**ADDENDUM
NO. 1**

June 23, 2022

Additions and Renovations to Edgewood Intermediate School
7620 E Edgewood Ave.
Indianapolis, IN, 46239

Addendum One (AD.01) to the drawings and specifications prepared by Gibraltar Design and The Skillman Corporation for **Edgewood Intermediate School Additions and Renovations** for Franklin Township Community School Corporation, Indianapolis, Indiana.

STRUCTURAL LEGEND

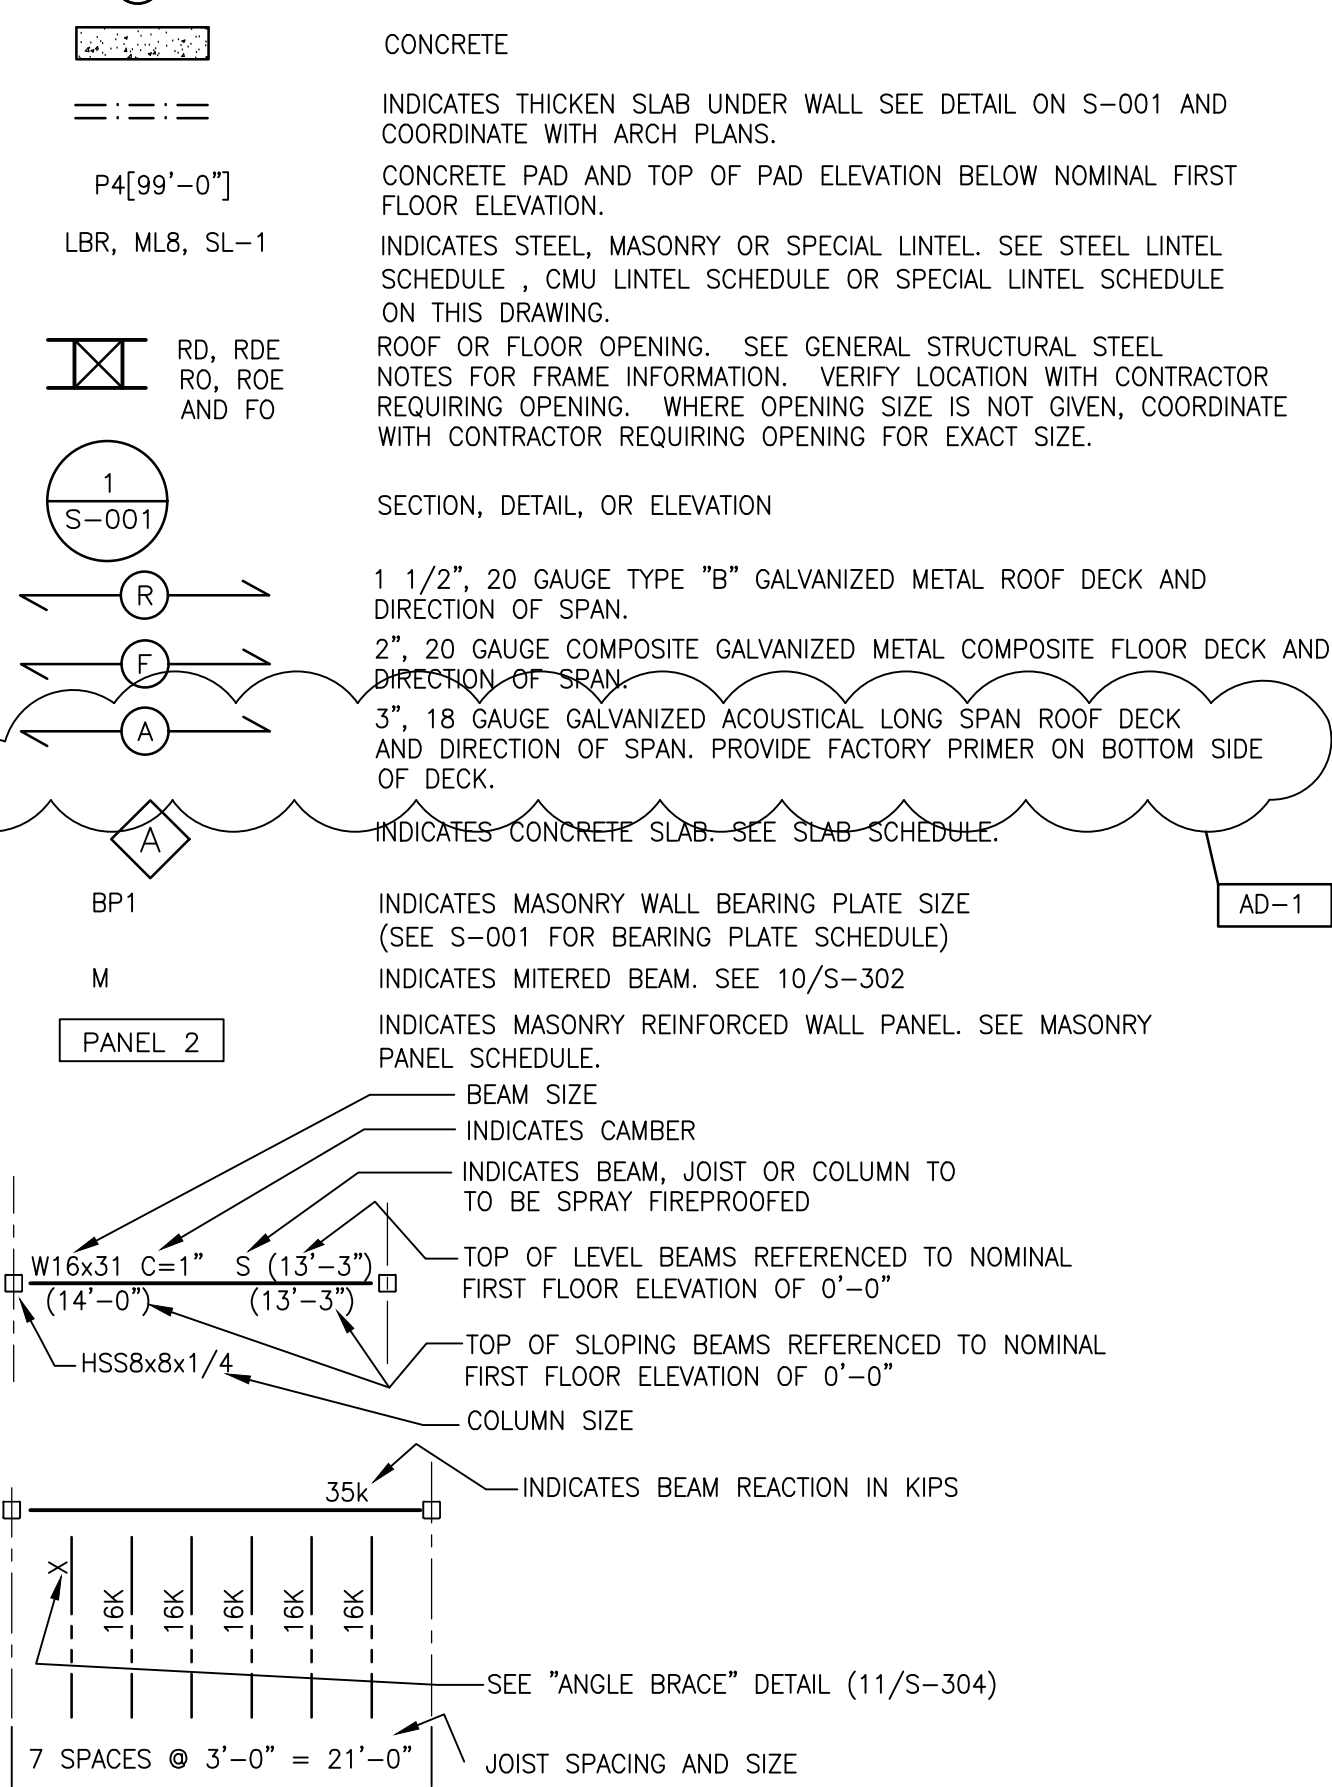
1. Remove the following text from note under 'Structural Legend' about acoustical long span metal deck being ("EPIC WIDECK type WP450A or approved equal").

© GIBRALTAR DESIGN SHEET
L SF113

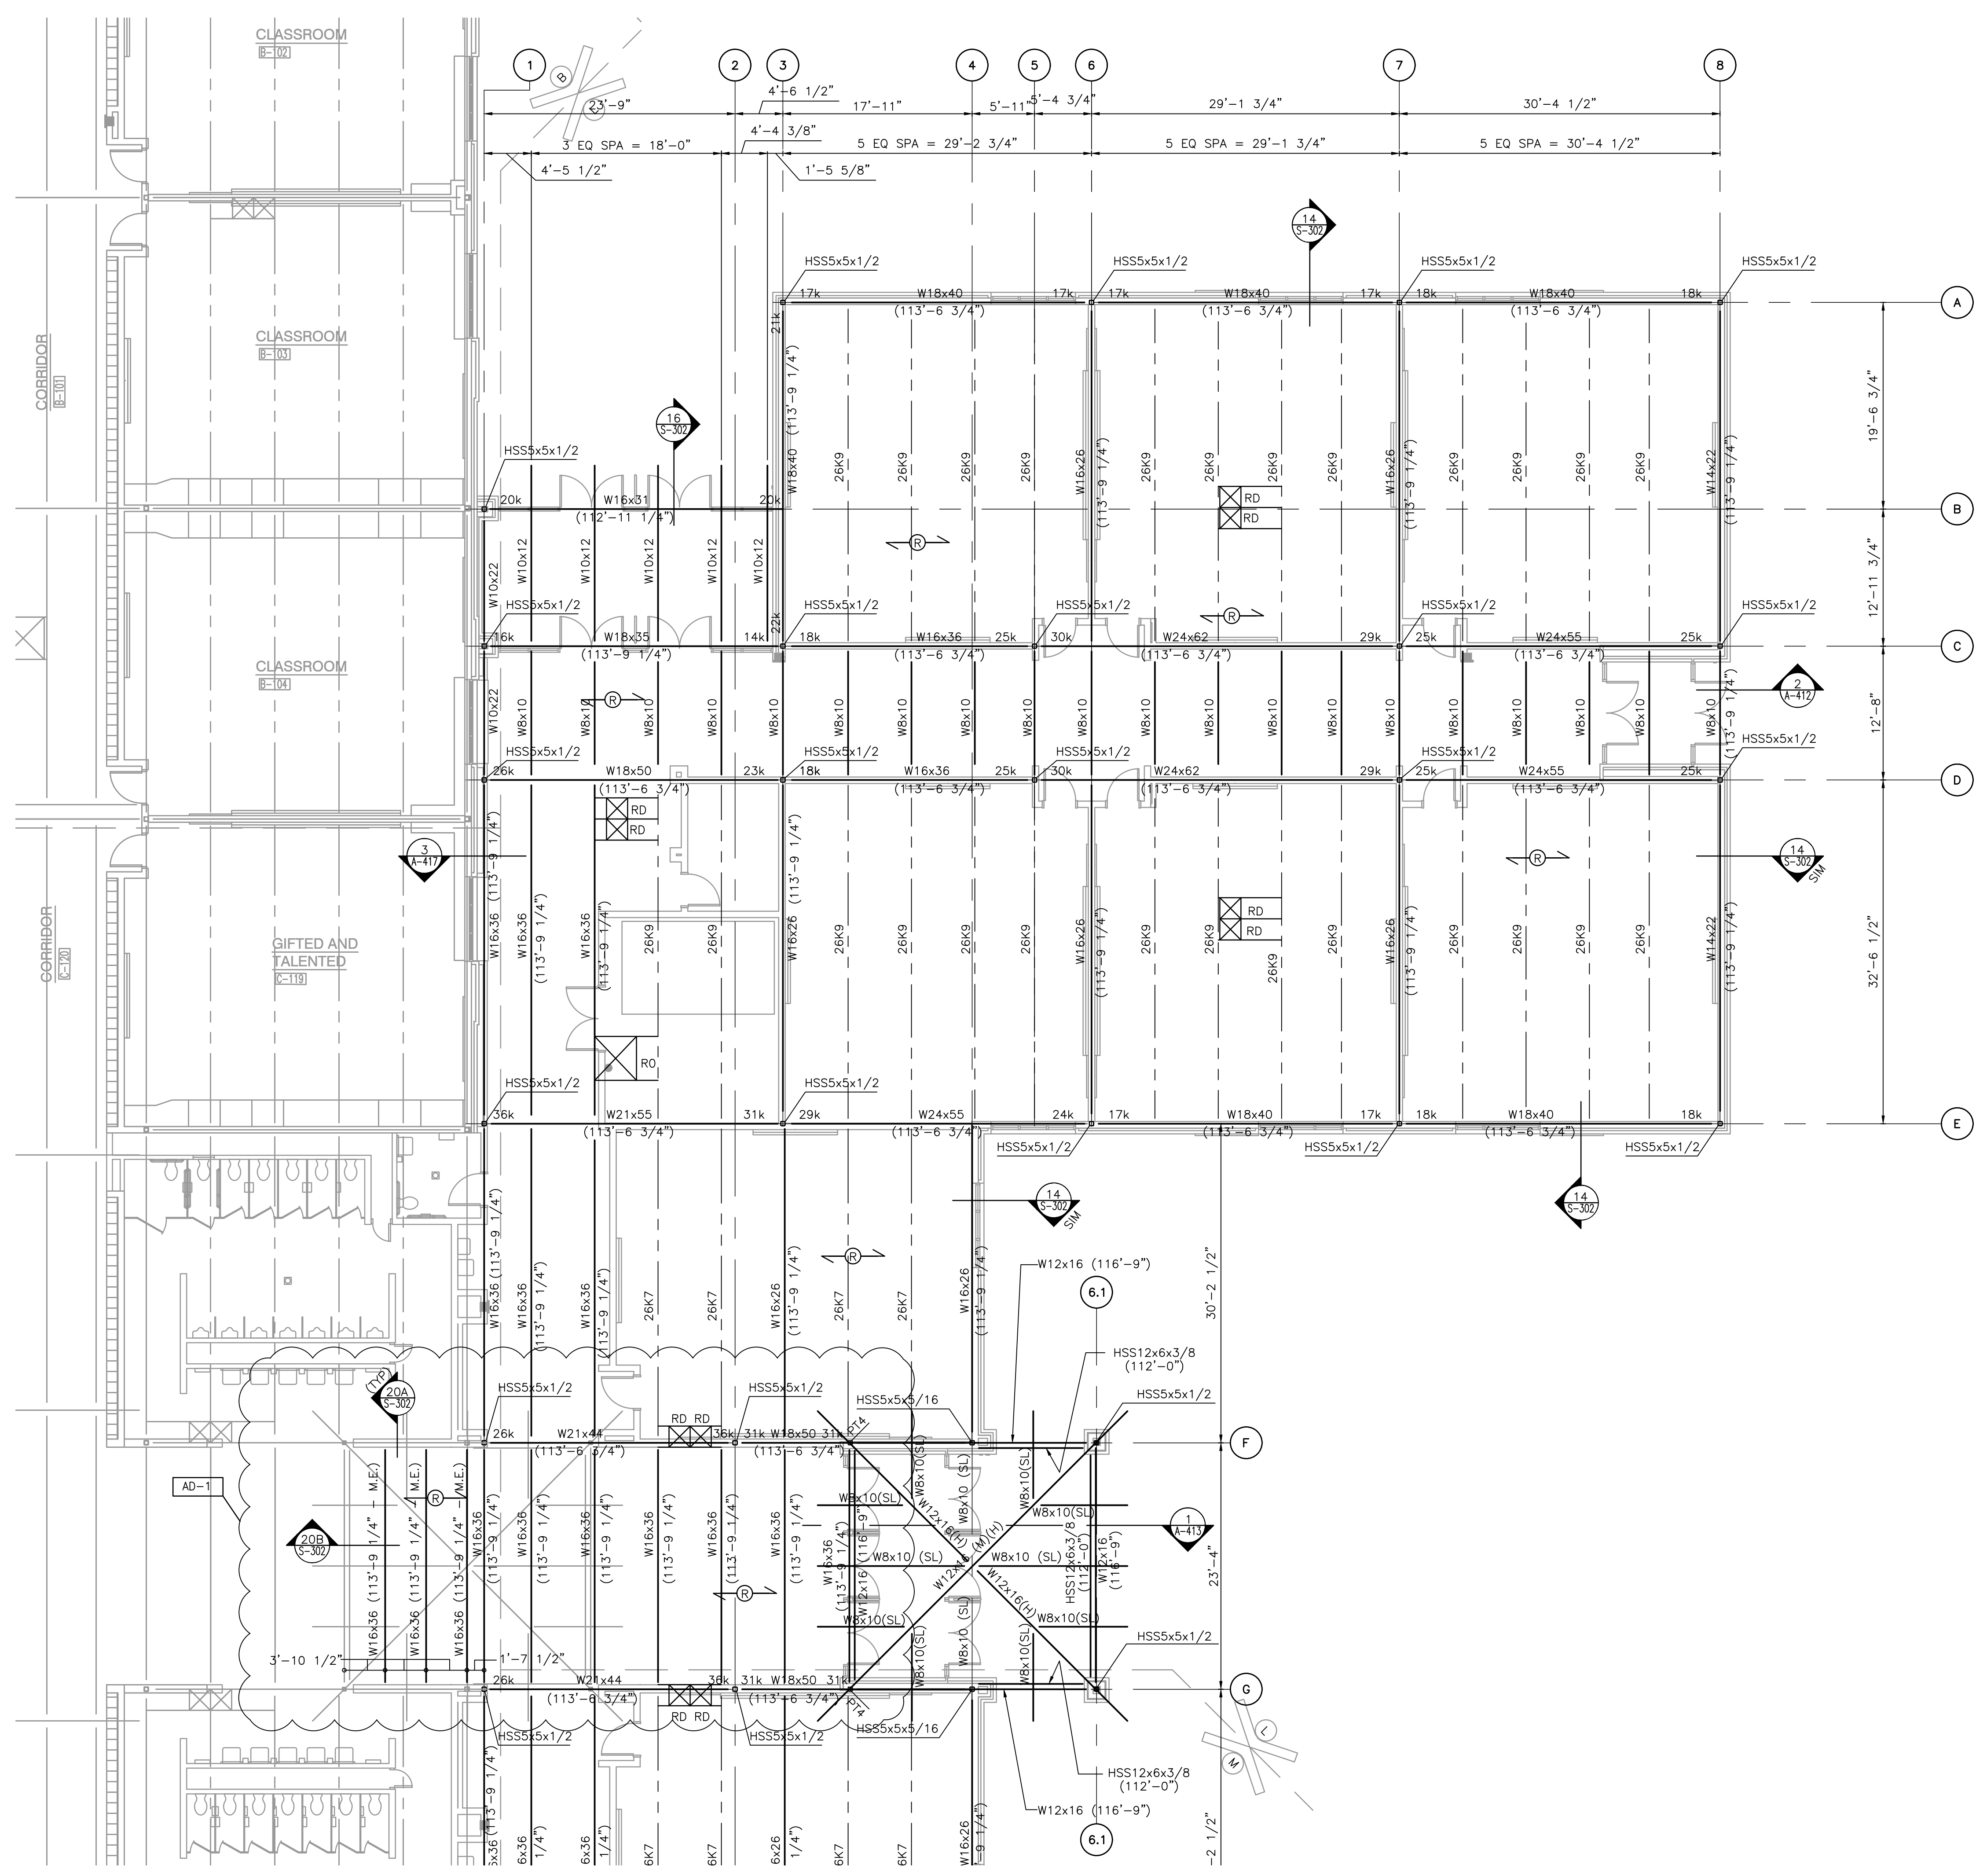
1. Change roof beams elevations from 113'-6 3/4" to 113'-9 1/4" between grids F and G from Grids 1 to 3.
2. Fill in section cuts along grids F and between grids F and G of area over top existing roof that required new roof deck infill w/20A and 20B/S-302.
3. Layout a dimension string for new beam infill of existing roof with new roof deck.

GYMNASIUM NORTH ELEVATION 2
SCALE: 1/4" = 1'-0" A-850

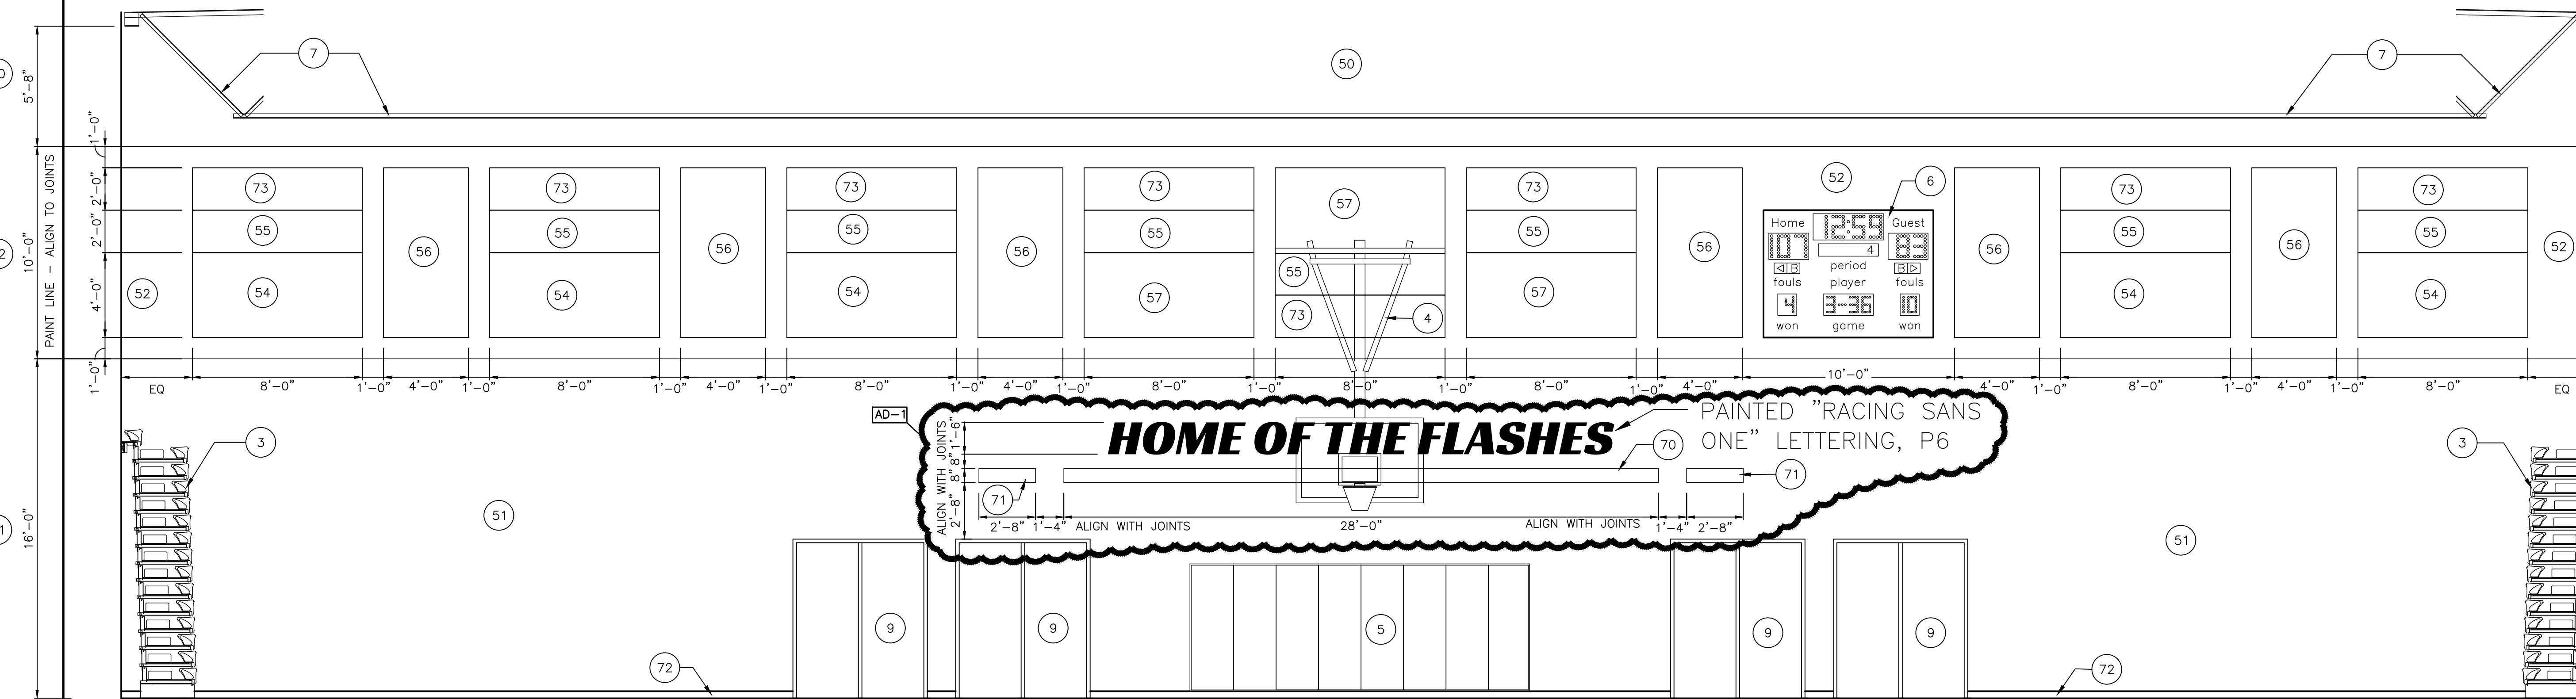
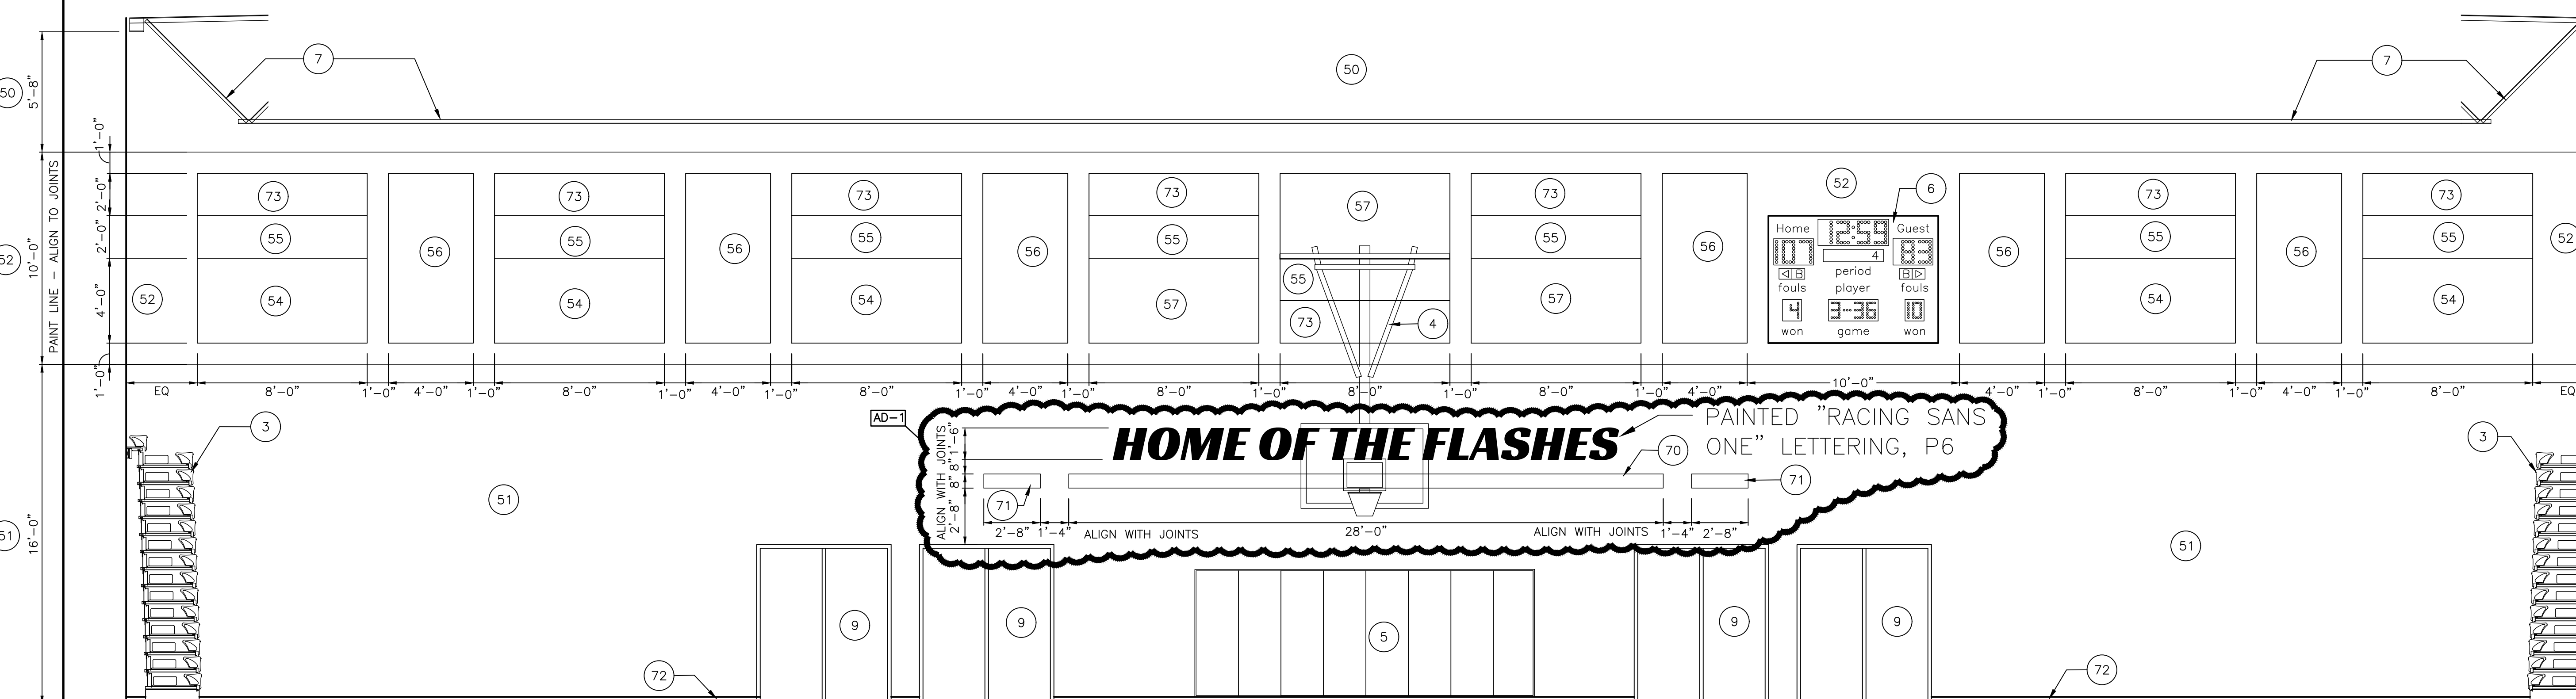
A. Refer to revised, full-size drawing, included in this Addendum, for addition of painted wall graphic on the north and south walls of the gymnasium.
